State of New Mexico
Energy, Minerals and Natural Resources

Form C-103
June 16, 2008

SUNDRY NOTICES AND REPORTS ON WELLS
(DO NOT USE THIS FORM FOR PROPOSALS TO DRILL OR TO DEEPEN OR PLUG BACK TO A DIFFERENT RESERVOIR USE "APPLICATION FOR PERMIT" (FORM C-101) FOR SUCH PROPOSALS)

Yates Petroleum Corporation wishes to convert this well to a Saltwater Disposal Well. Yates has an Administrative Order SWD-1129 dated June 5, 2008. See attached procedure.

WELL NAME: Loving SWD #1

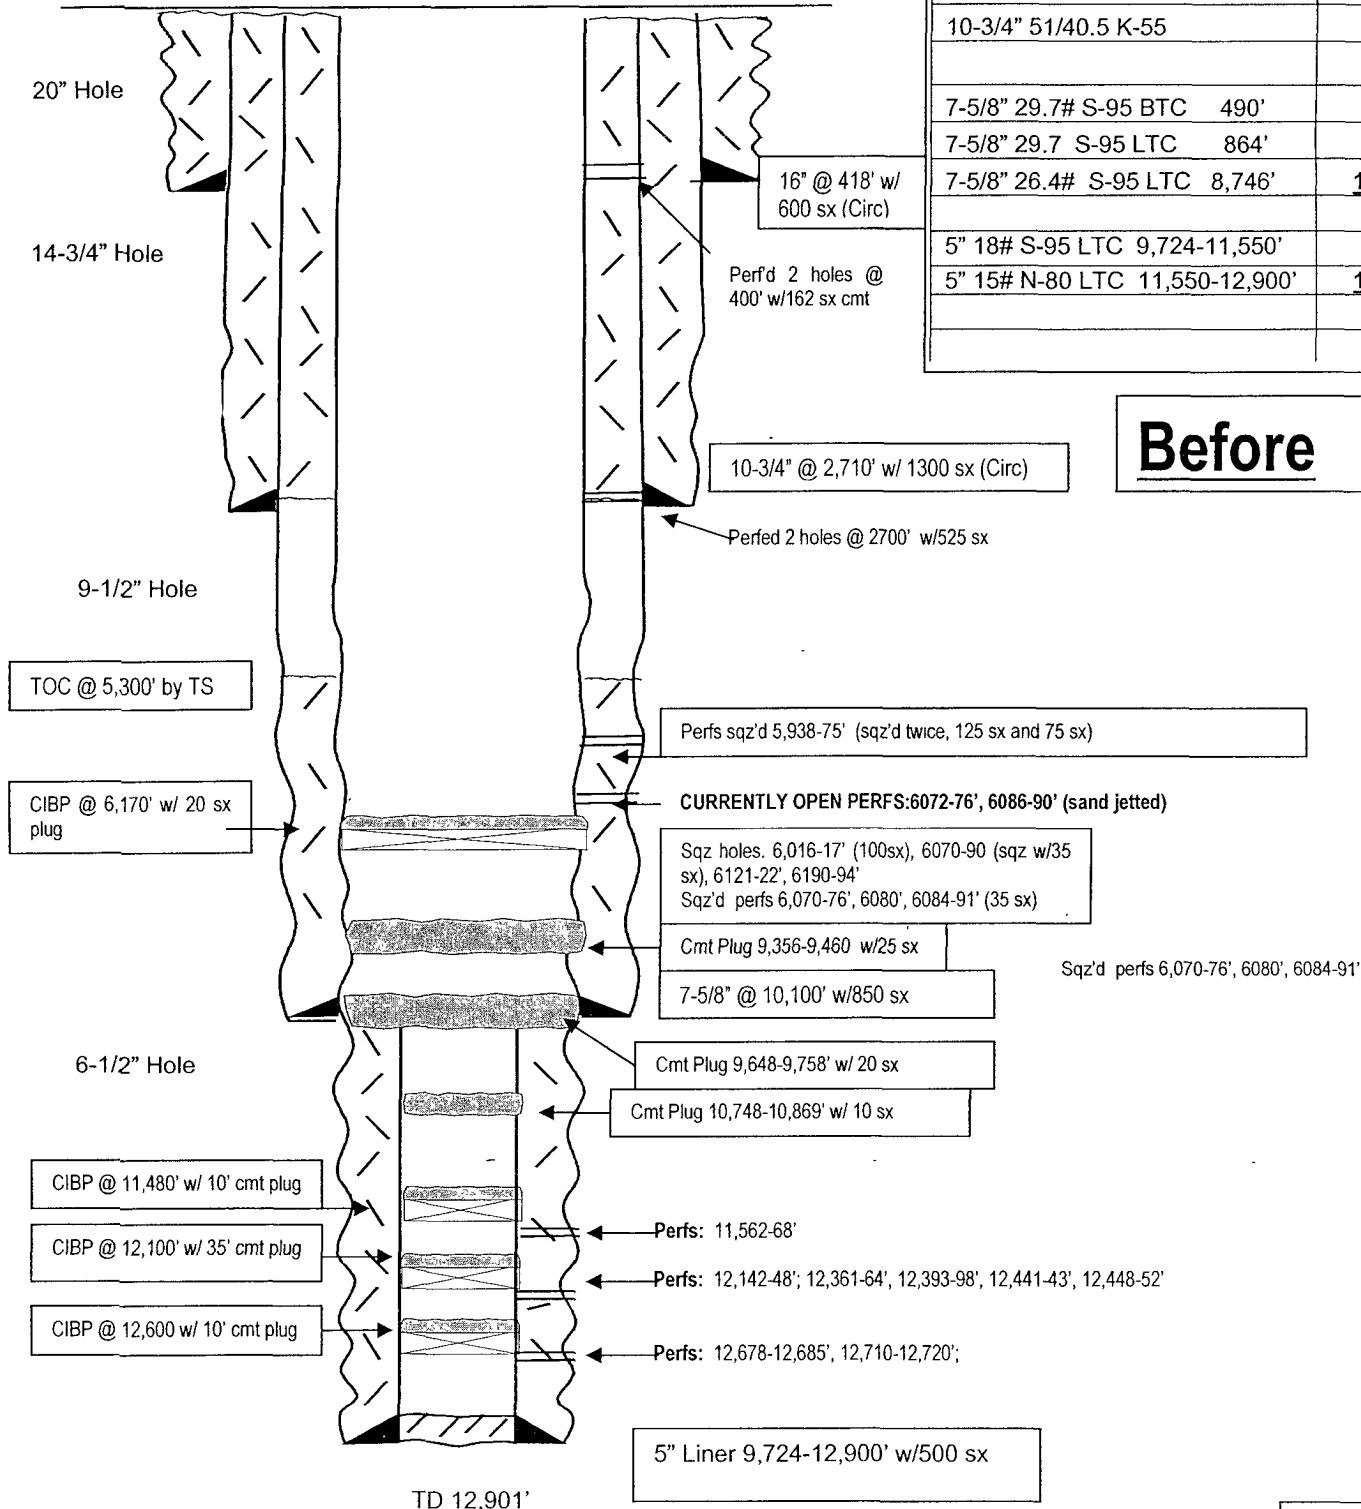
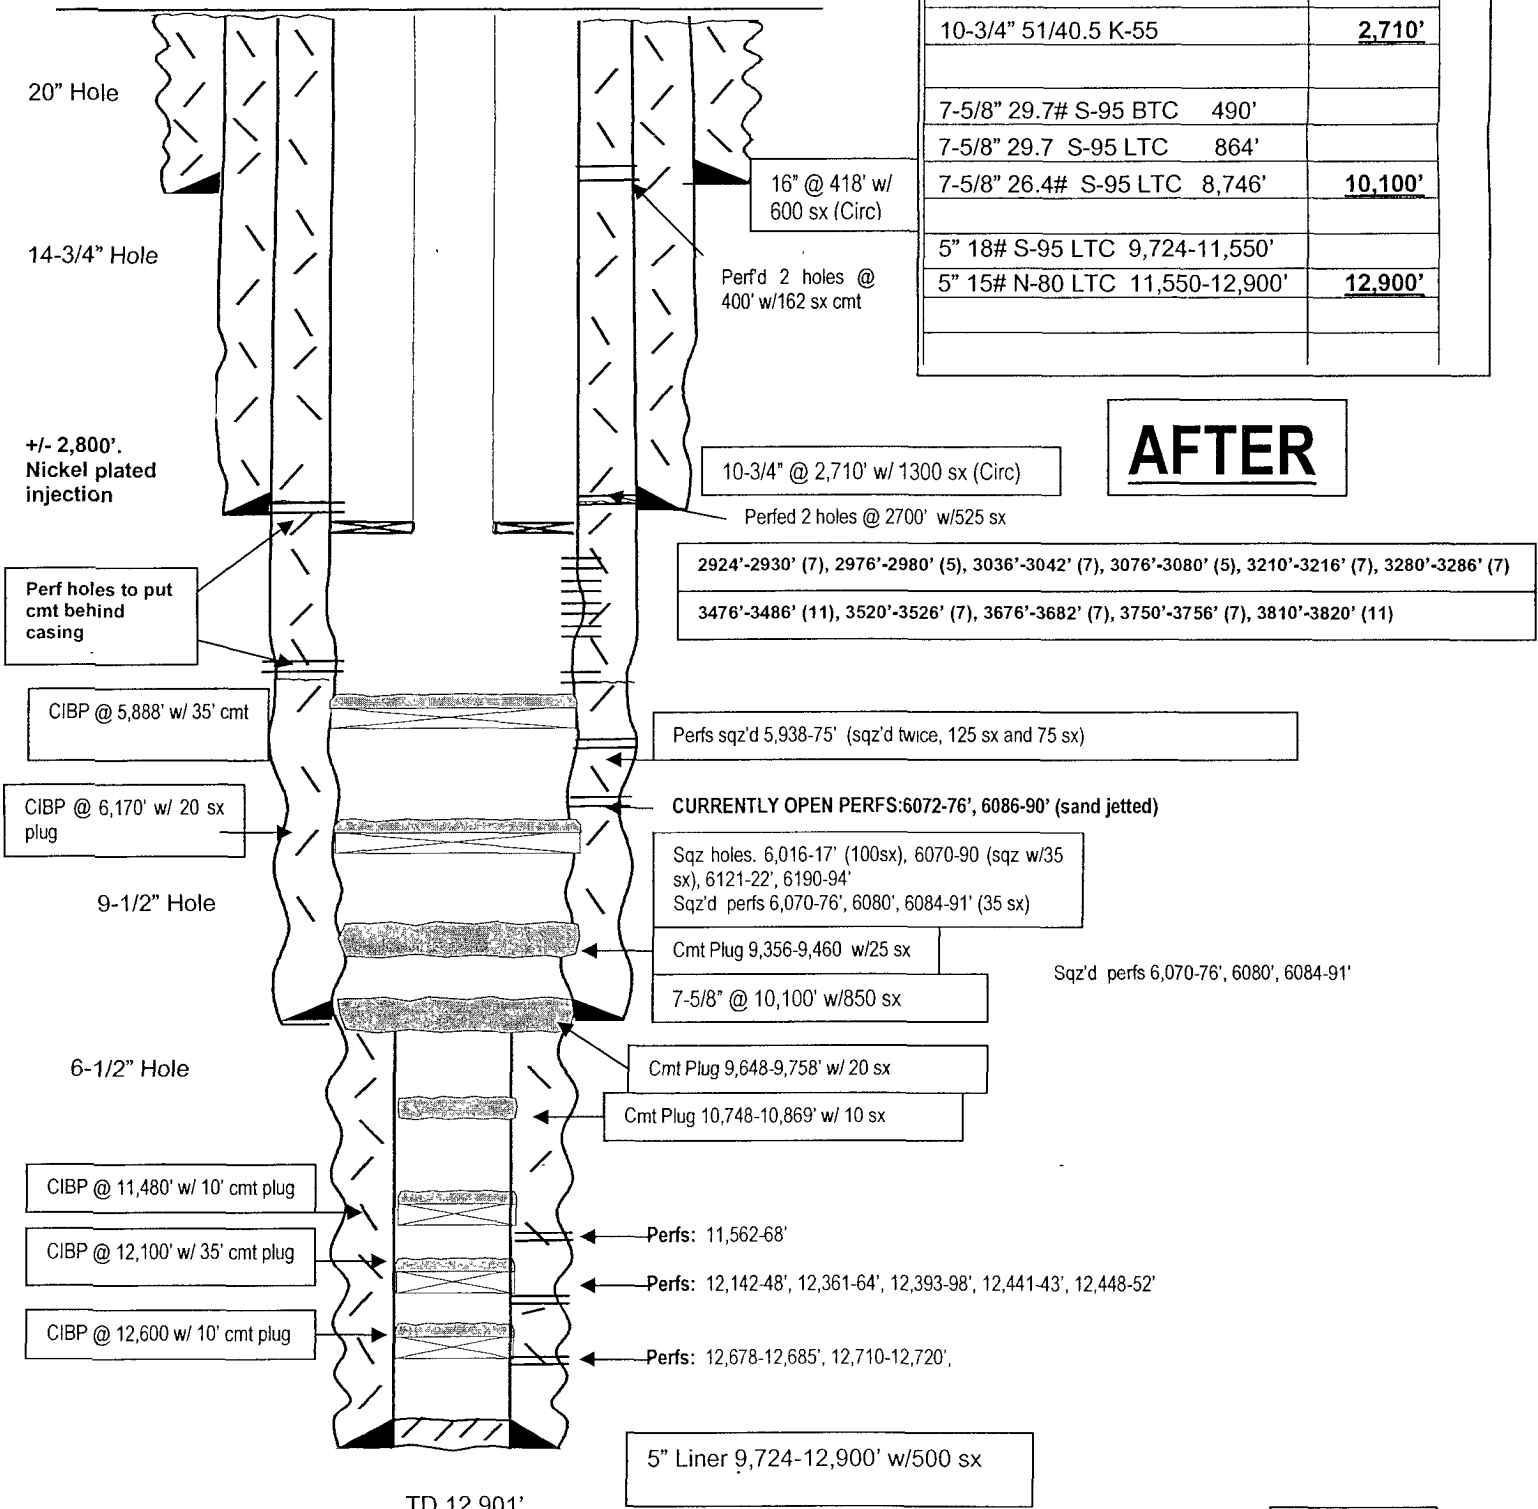
Yates Petroleum Corporation wishes to convert this well to a Saltwater Disposal Well. Yates has an Administrative Order SWD-1129 dated June 5, 2008. Yates plans to move in a pulling unit and install a BOP rated for 3000#. Rig up all safety equipment as necessary. Pull the rods & tubing out of the well bore and all production equipment. Then set a CIBP at about 5888' and cap with 35' of cement. Top of cement determined from the bond log was 5300'. There are perforated holes at 2700' from previous cement job to get cement to the surface. Yates will then run a Cement Bond Log over the interval, then use the log to determine where to perf and put cement behind the pipe in the current no cement interval 2700'-5300'/ Squeeze with Class "H" cement and wait 48 hours before drilling out. Yates will then perforate the Bell and Upper Cherry Canyon Delaware sands as follow:

3476'-3820', 3520'-3526', 3676'-3682', 3750'-3756' & 3810'-3820' and frac.

Set a CIPB at 3350' and perforate the Bell Canyon Delaware sand as follows:

2924'-2930', 2976'-2980', 3036'-3042', 3076'-3080', 3210'-3216' & 3280'-3286' and frac.

Shut the well in for a minimum of 4 hours to allow gel to break. Flow well back if it will flow. Trip in hole and circulate out sand and drill out the composite plug at 3350'. Pull out of the hole. Trip in the hole with a nickel plated packer, set at +/-2,824' and 3 1/2" plastic coated tubing.

See attaché before and after diagrams.
